E5070B-15

S E R V I C E N O T E

E5070B ENA Series Network Analyzer, 300 kHz to 3 GHz

When replacing A51 LCD, fasten the TORX T15 screws using a torque screwdriver (set to 1.02 N-m / 9.0 lb-in).

e5070bse3014

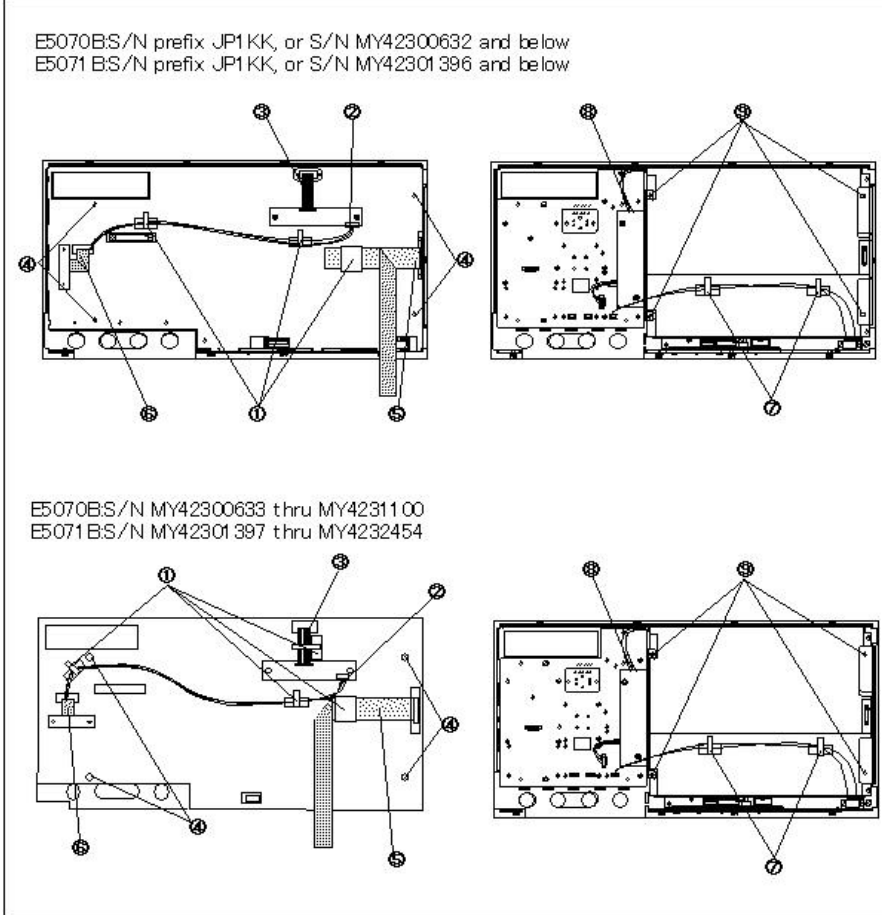
When replacing the A51 LCD, no torque info is shown in the service guide.

If you fasten the screw with over the appropriate torque, A51 LCD might be damaged, and if you fasten the screw with under the appropriate torque, LCD module might not be fixed against the vibration.

Fasten the TORX T15 screws (item 9) using a torque screwdriver (set to 1.02 N-m / 9.0 lb-in).
